DESIGN WAIVER REQUEST FORM

PROJECT DATA	
Current Project Phase	Context/Scoping ☐ Footprint Established ☐ Plan-in-Hand ☐ PS&E ☐ (Base Technical Concept for Design-Build RFP)
County/ City	Lauderdale
PIN	136185.02
Federal Project No.	N/A
State Project No.	R4SVAR-S1-049 (DB 2506)
Project Limits	SR 87 Bridge over Lagoon Creek, L.M. 3.61
Local Program Project	Yes ☐ No ☒ If yes, then
State Let	Yes ☒ No ☐
Local Let	Yes ☐ No ☒
Project Type	New Alignment ☐ Reconstruction ☐ Resurfacing ☐ Road Diet/Road Reconfiguration ☐ (Note: Road Diet Evaluation form may be required) Maintenance ☐ Road Safety Audit ☐ Bridge Repair ☐ Bridge Rehabilitation ☒ Signilization ☐ Other ☐
US Route/NHS	Yes ☐ No ☒
State Route	Yes ☒ No ☐
Appalachian Development Highway System	Yes ☐ No ☒
FHWA RBI Project	Yes ☐ No ☒
Project Scope (Briefly describe the objective of project)	Replacement of existing Timber Bridge over Lagoon Creek
Project Commitments	N/A

STATE ROUTE 87
BRIDGE OVER
LAGOON CREEK L.M. 3.61

LINE AND GRADE
BRIDGE REPLACEMENT

STATE OF TENNESSEE DEPARTMENT OF TRANSPORTATION
PROPOSED PROFILE
STA. 96+35.00 TO STA. 108+35.00
SCALE: 1" = 50' HORIZ. 1" = 5' VERT.

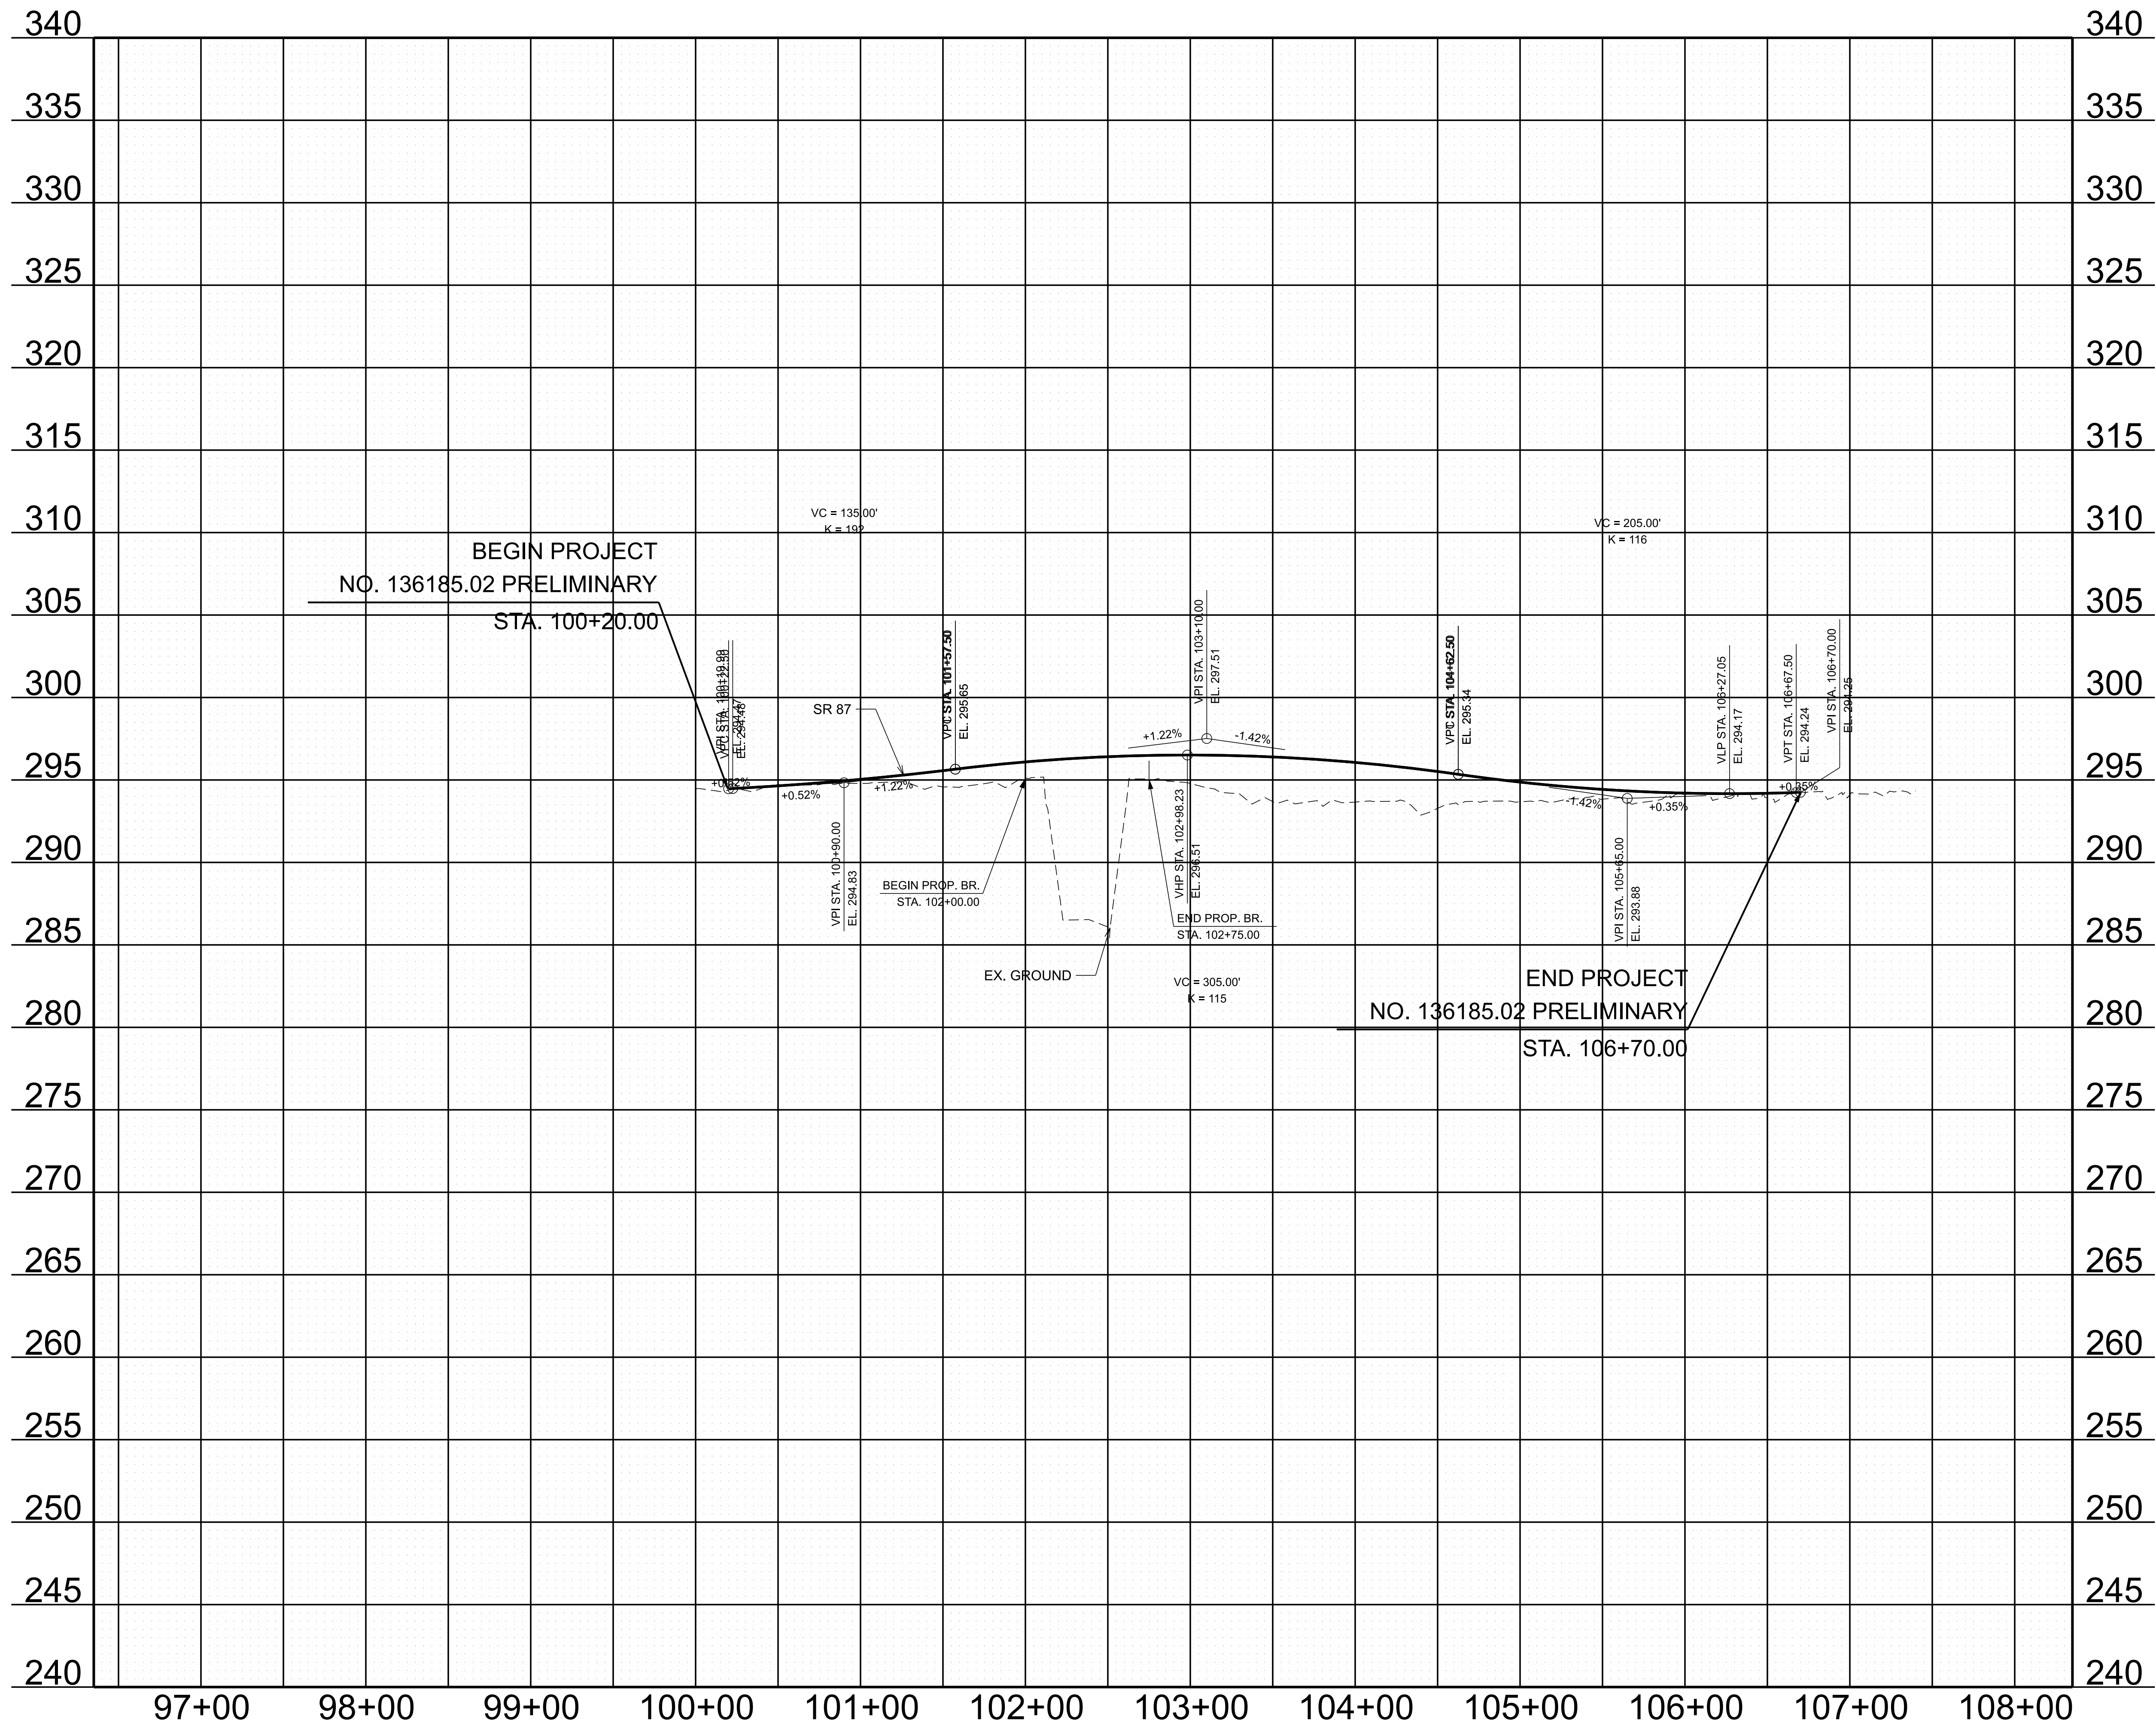
The purpose of this project is to replace an existing timber bridge. The existing bridge is located less than 200' from an existing box culvert bridge to the west. The intent is to replace the timber bridge and to not impact the box culvert bridge. Per direction from TDOT hydraulics, the new bridge must maintain the existing low chord elevation. Therefore a grade raise is required to meet this requirement. A proposed vertical curve with a “K” value of 55 MPH cannot be achieved without creating a significant grade raise and an impact to the existing box culvert bridge. Therefore, a 45 MPH vertical curve is requested. Impact to the box culvert bridge would

Multiple beam types were considered; however, it was determined that a min. 36" box beam will be required to span Lagoon Creek. The depth of the proposed beam dictates the need to raise the roadway grade in order to maintain the existing low chord elevation. Multiple vertical alignments were analyzed. The vertical alignment shown in the BTC that represents the 55 mph curve moves the PI off the bridge to the east, which raises the grade and adds to the project limits to the east. This option still poses a concern to tie down before the box culvert bridge on the west. A proposed 45 mph vertical alignment will help minimize overall impacts of this project including the potential need to replace the existing culvert bridge to the west.
